MONTGOMERY COUNTY HISTORIC PRESERVATION COMMISSION
STAFF REPORT

Address:	10201 Menlo Ave.	Meeting Date:	10/25/17
Resource:	Contributing Resource Capitol View Historic District	Report Date:	10/18/17
Review:	HAWP	Public Notice:	10/11/17
Case Number:	31/07-17G	Tax Credit:	None
Applicant:	Minter Farnsworth	Staff:	Dan Bruechert
Proposal:	New Construction

Address:	10201 Menlo Ave.	Meeting Date:	10/25/17
Resource:	Contributing Resource Capitol View Historic District	Report Date:	10/18/17
Review:	HAWP	Public Notice:	10/11/17
Case Number:	31/07-17G	Tax Credit:	None
Applicant:	Minter Farnsworth	Staff:	Dan Bruechert
Proposal:	New Construction

TREE SURVEY
1" = 20'
Proposed Trees to be Removed

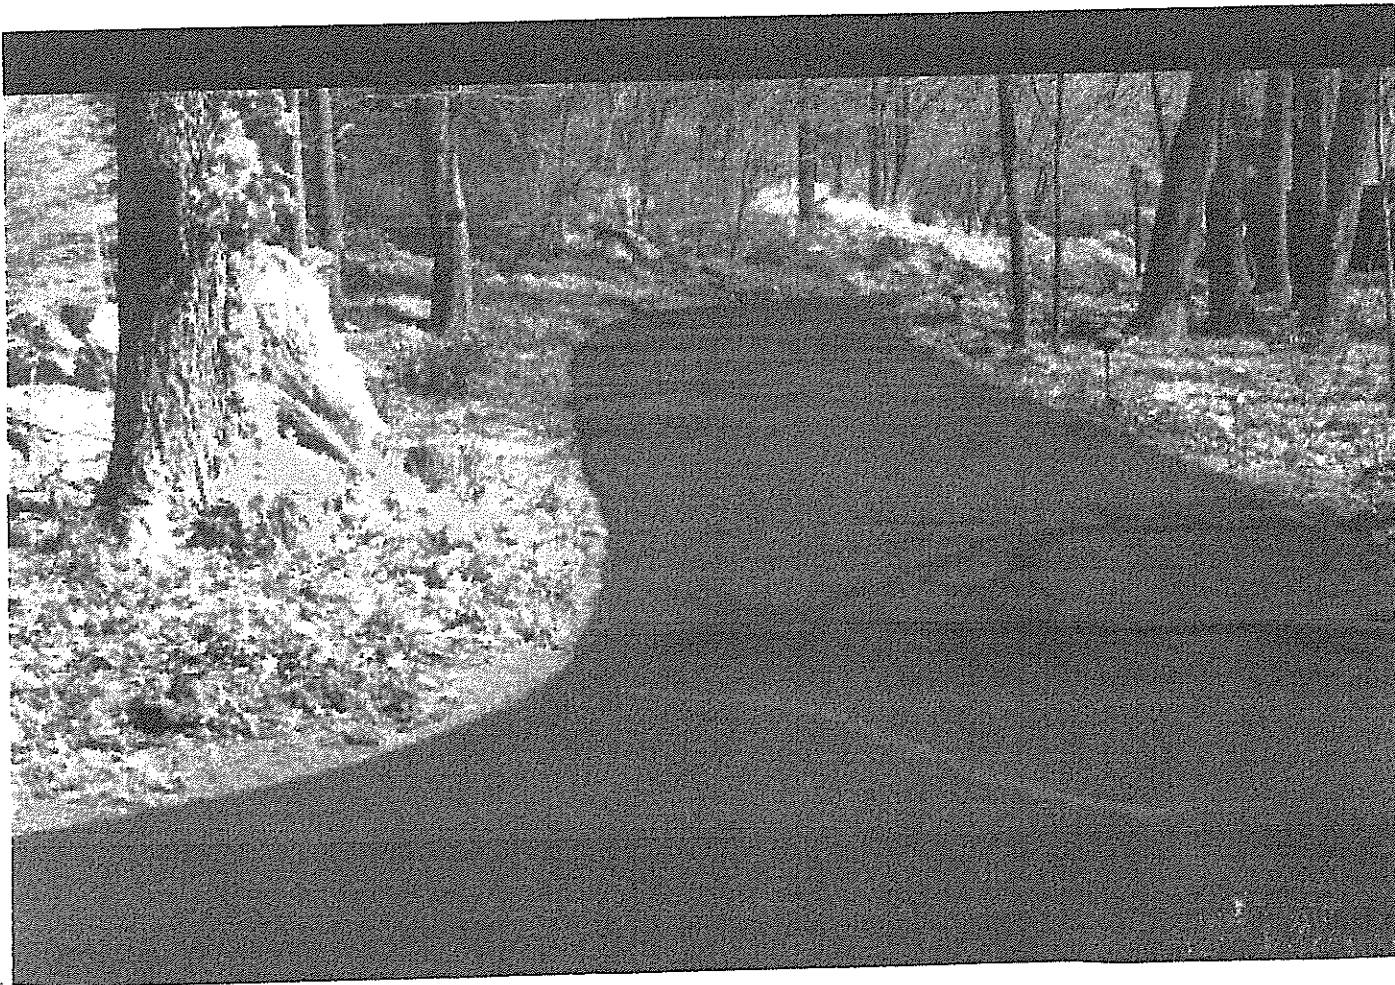
The applicant will need to remove several trees in order to develop the lot. The applicant has identified a total of seven trees proposed for removal (see the attached Tree Survey). Four trees are at the edge of the property and are located at the only access point from the property to the public streets. The other three trees are placed where the house is proposed. Due to the unique lot placement and the slope of the lot, the driveway and house could not be placed anywhere else on the site. Staff feels that the loss of these trees is unavoidable and recommends approval for their removal. To deny the tree removal would deprive the owner of reasonable use of the property as zoning currently allows this lot to be developed with a single-family home (24A-8(b)(5)).

The applicant will need to remove several trees in order to develop the lot. The applicant has identified a total of seven trees proposed for removal (see the attached Tree Survey). Four trees are at the edge of the property and are located at the only access point from the property to the public streets. The other three trees are placed where the house is proposed. Due to the unique lot placement and the slope of the lot, the driveway and house could not be placed anywhere else on the site. Staff feels that the loss of these trees is unavoidable and recommends approval for their removal. To deny the tree removal would deprive the owner of reasonable use of the property as zoning currently allows this lot to be developed with a single-family home (24A-8(b)(5)).

**PROPOSED FENCING:
PRESSURE TREATED 1" X 6" VERTICAL
6' HIGH PRIVACY FENCING WITH NATURAL FINISH
LOCATION AS PER SITE PLAN DRAWING**

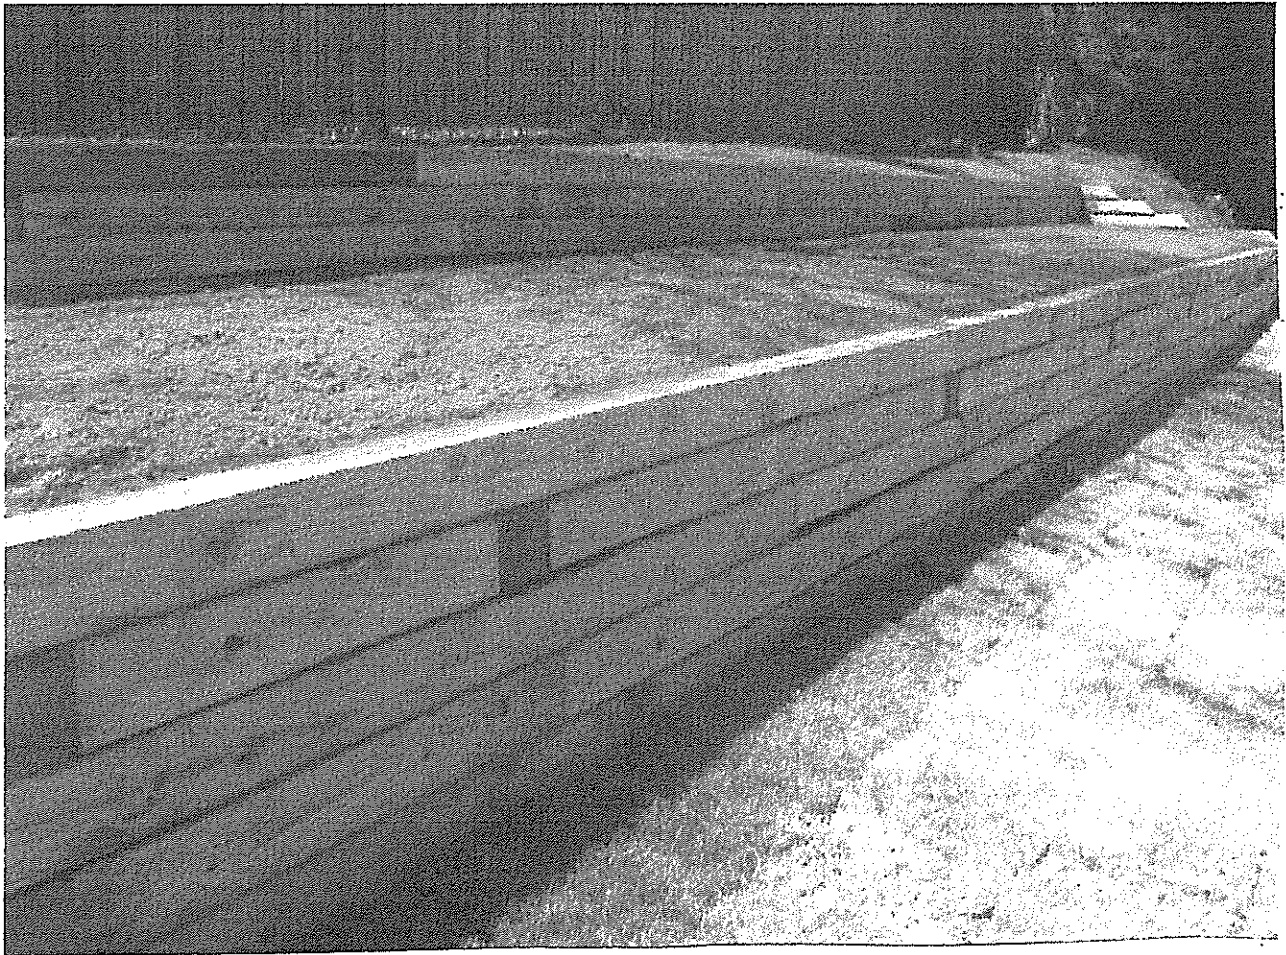
The applicant is proposing to install a six foot (6') tall, wood, board on board privacy fence placed at the front boundary of the property. The HPC does not typically approve fences taller than forty-eight inches (48") in front of the rear wall plan within historic districts. The neighboring property has a fence that is approximately five feet (5') tall, which would intersect the proposed fence at the middle. The southern half of the proposed fence will be obscured by the neighbors existing fence and will not be visible. The northern portion of the fence will be will be visible from the public right of way and staff believes that due to the unique siting of the lot, a solid board on board design is acceptable, however, the fence height should be reduced to 48" (forty-eight inches) to the north of the neighbor's wooden fence.

1. The windows must be either wood or clad, not vinyl, and have fixed interior and exterior grids. Details need to be submitted to Staff for review and approval with final approval authority delegated to staff.
2. The proposed fencing must be lowered to no higher than 48" (forty-eight inches) above grade north of the neighbors existing privacy fence.
3. Due to the site's environmentally sensitive location an erosion plan must be submitted for review and approval with final authority delegated to staff.

Deck

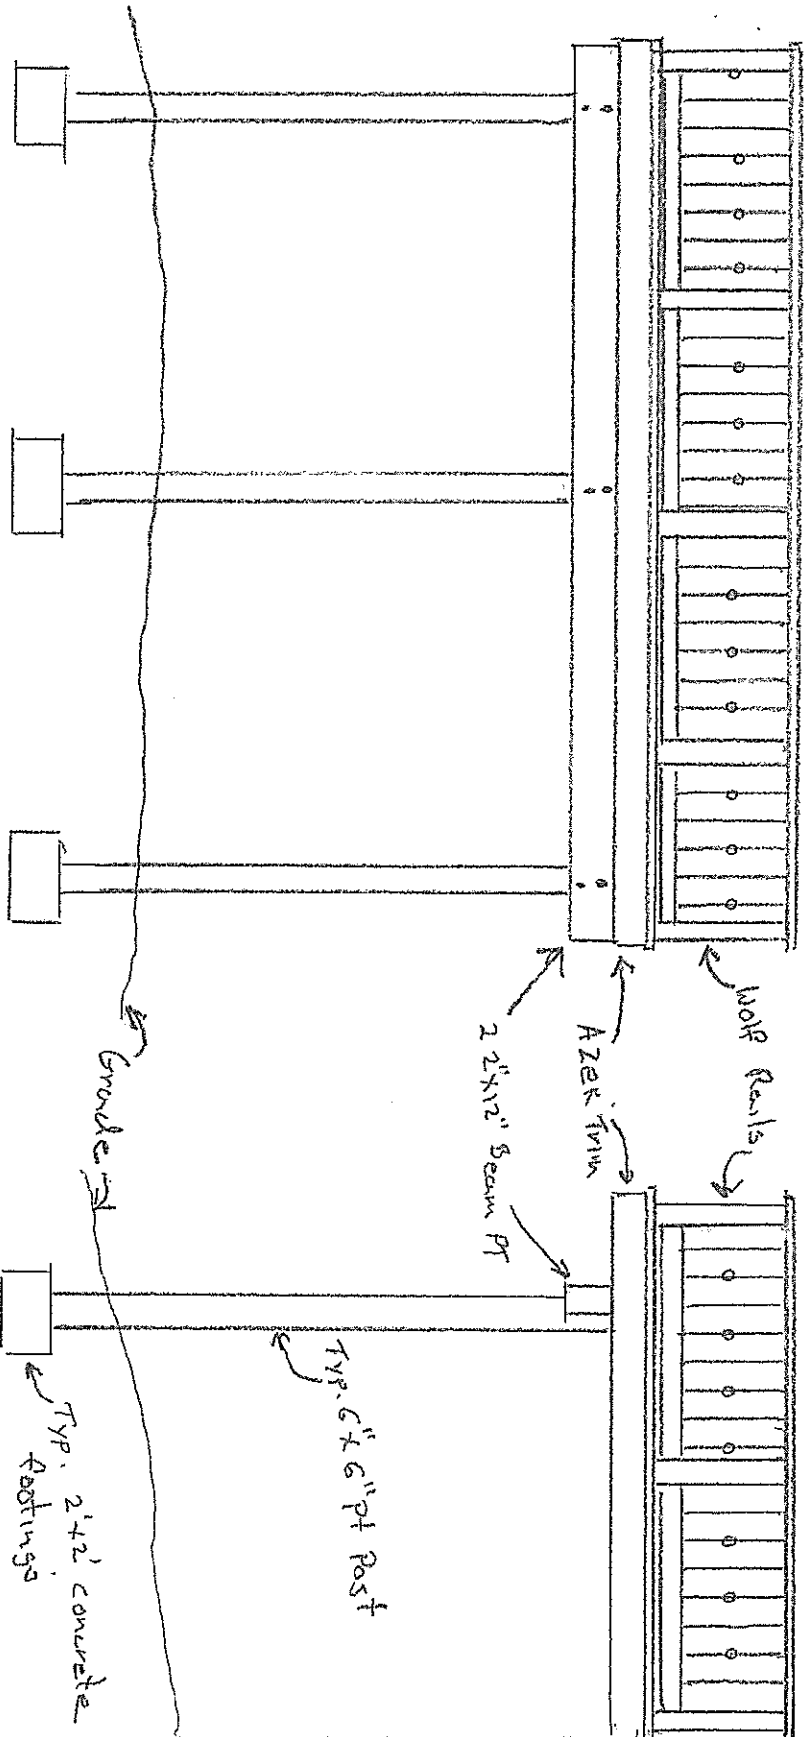
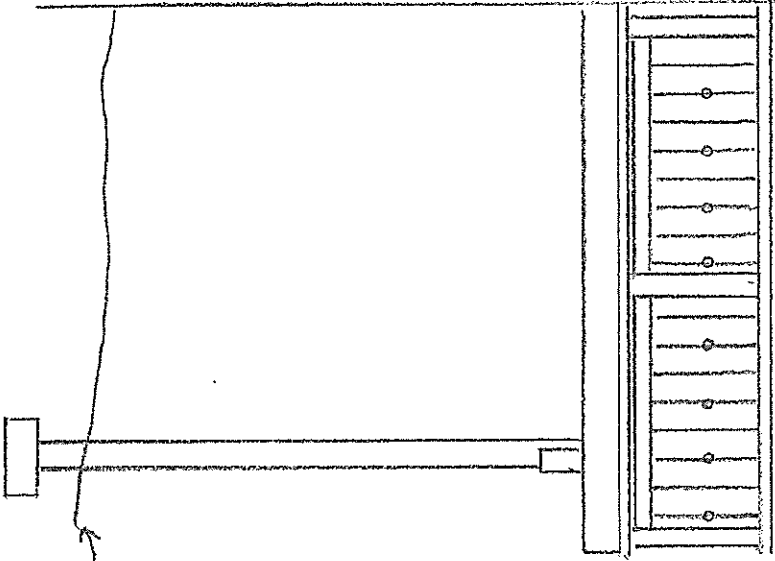
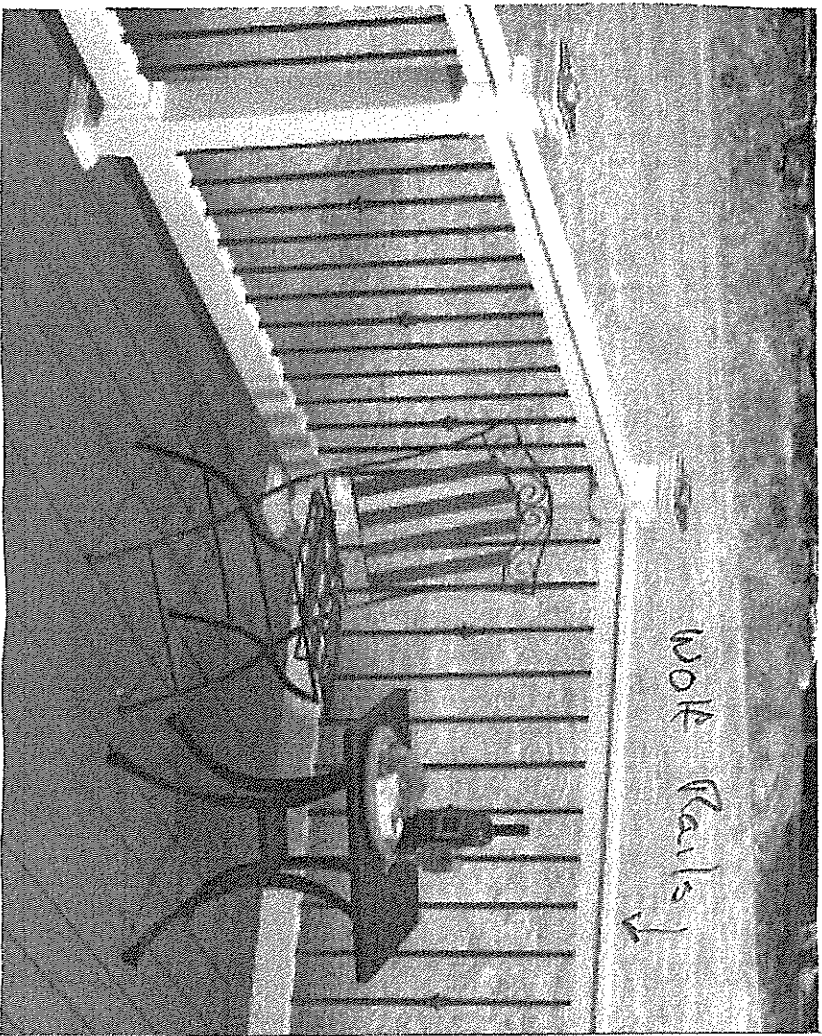
The applicant proposes to construct a 12' × 20' (twelve feet by ten feet) deck to the rear (the deck details are on included on the elevation drawings and were provided as a supplement to the application). The applicant proposes to construct the structure of the deck out of wood, with a composite decking material, azek trim, and ‘Wolf’ metal rails. Staff feels that the composite decking and azek trim are acceptable substitute materials in this location due to the fact that their characteristics are similar to wood. Staff also feels that the metal balusters are acceptable in this location because the deck is at the rear on new construction. As this will not be visible from the public right-of-way, Staff believes this decorative element should be approved.
